**GENOA CHARTER TOWNSHIP
PLANNING COMMISSION PUBLIC HEARING
MARCH 13, 2017
MONDAY
6:30 P.M.
AGENDA**

OPEN PUBLIC HEARING #1...Review of site plan application and impact assessment for a proposed 101 room 4 story “Hampton Inn and Suites” hotel located southwest of the Grand Oaks Drive and Latson Road intersection. The property is located within the Livingston Commons Phase 2 PUD on parcel #11-08-200-020. The request is petitioned by Howell Hospitality Inc.

Attention:	Kelly Van Marter, AICP Planning Director and Assistant Township Manager
Subject:	Hampton Inn & Suites – Site Plan Review #2
Location:	Vacant property southwest of the Grand Oaks Drive and Latson Road intersection
Zoning:	NR-PUD Non-Residential Planned Unit Development District

Re: Hampton Inn – Site Plan Review #2

FIRE TRUCK CIRCULATION

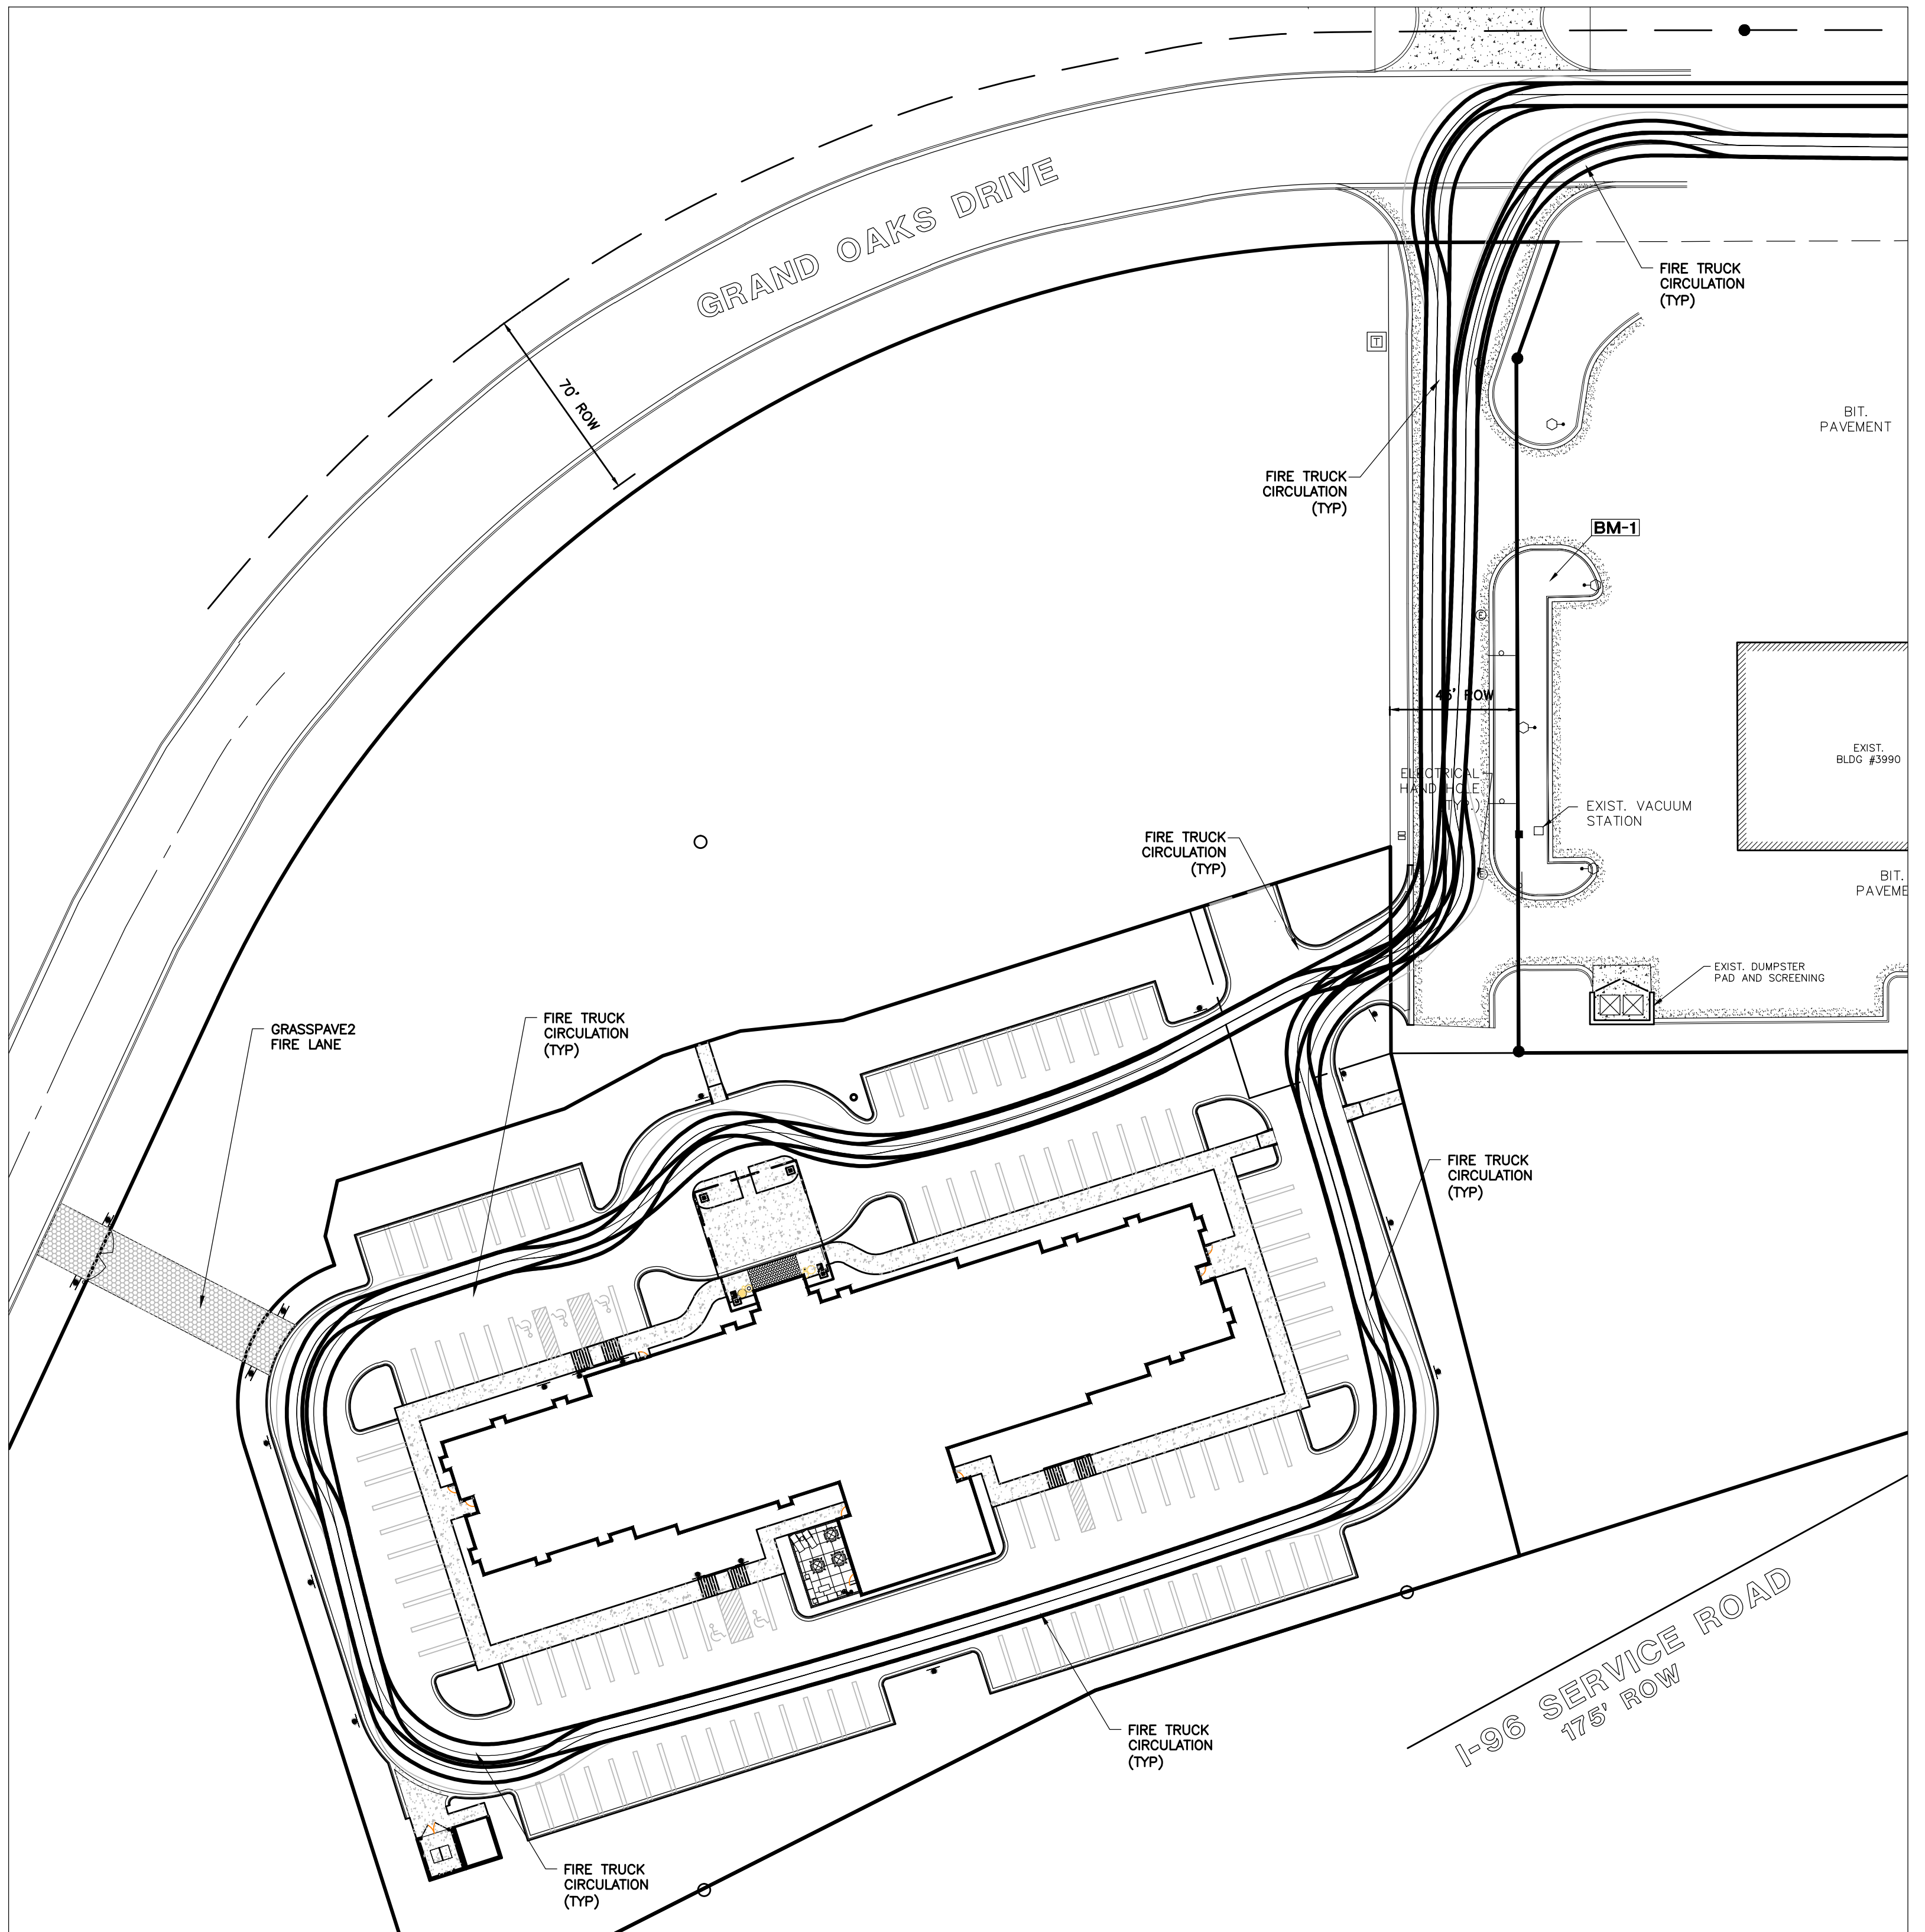
5. All turns along the access around building shall provide emergency vehicles with a turning radius of 50' Outside and 30' Inside to accommodate aerial apparatus. Radius around porte-cochere. **(An emergency vehicle circulation plan has been provided on Sheet C3.0 and appears to be in compliance with proper turning radius.)**
IFC D103.3

UTILITY PLAN

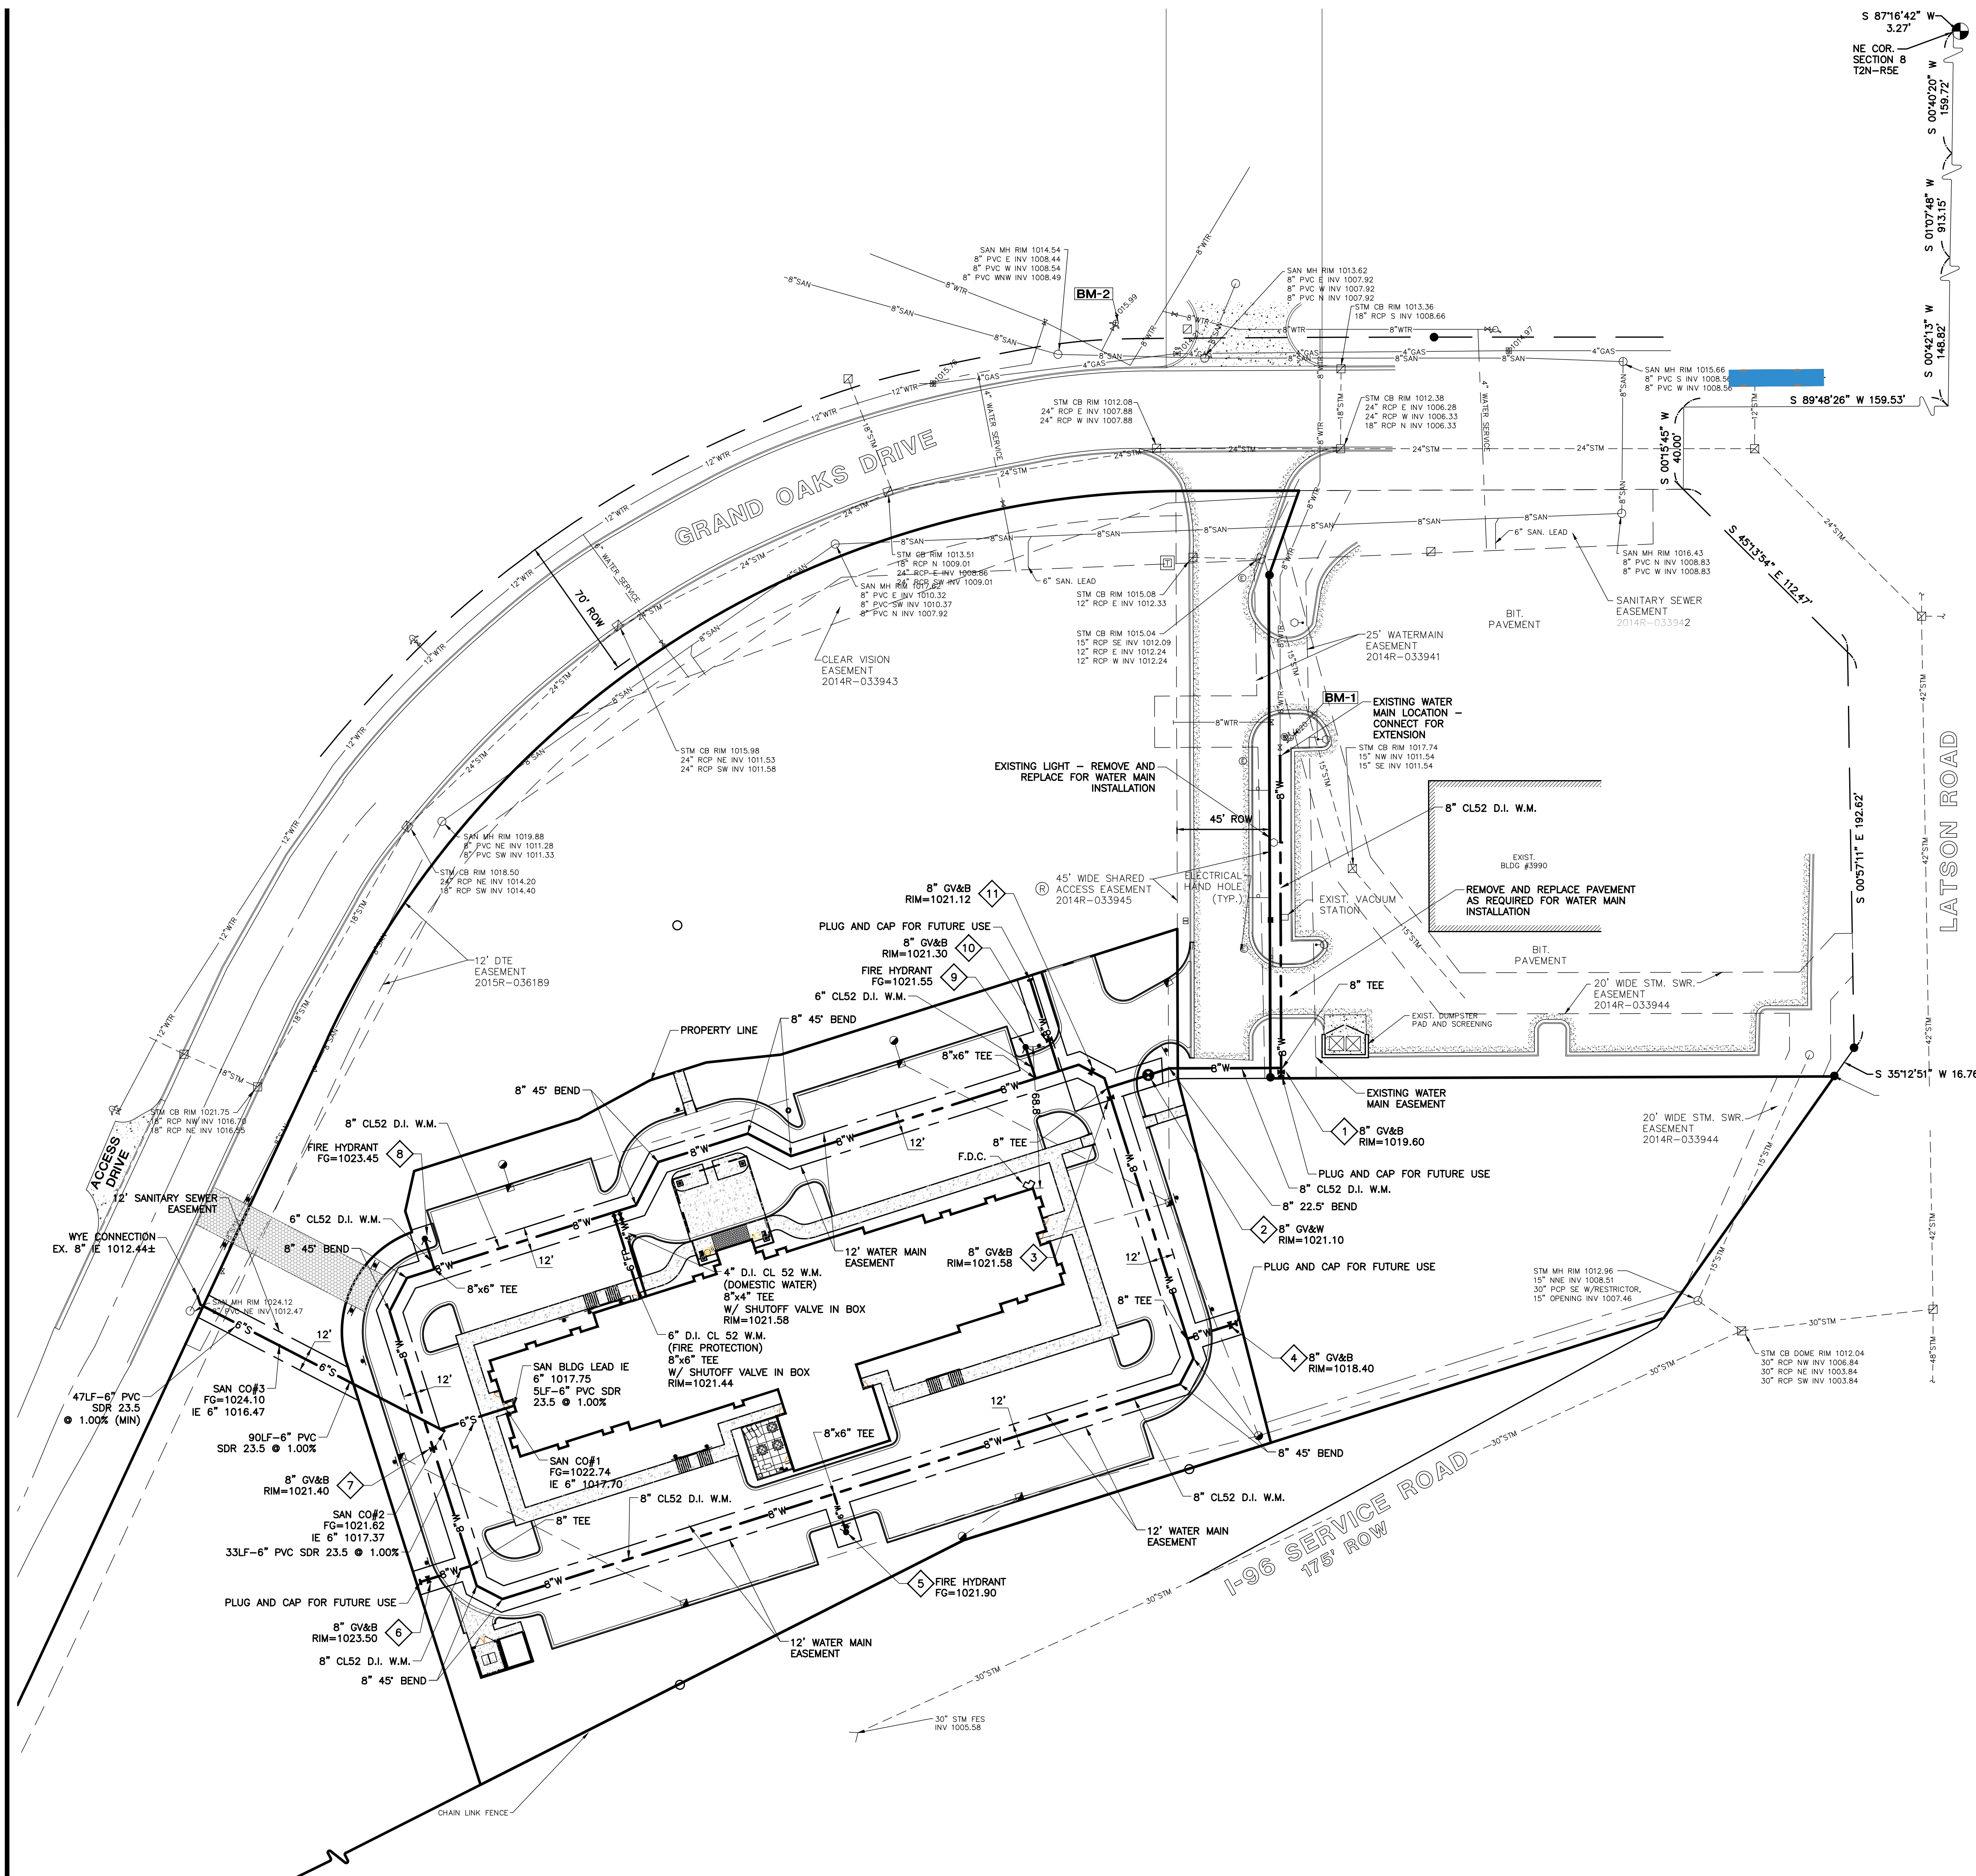
1. Hydrant locations and spacing are acceptable and shall be installed in accordance with MHOOG standards. **(Locations shown on Sheet C5.0 are approved)**

- A. The FDC shall be located on the front of the building (Grand Oaks Dr.), and shall be located within 100' of a fire hydrant. The northeast corner of the building is recommended or immediately outside of the sprinkler riser room. Show FDC location on future submittals. **(Shown on Sheet C5.0 in correct location)**
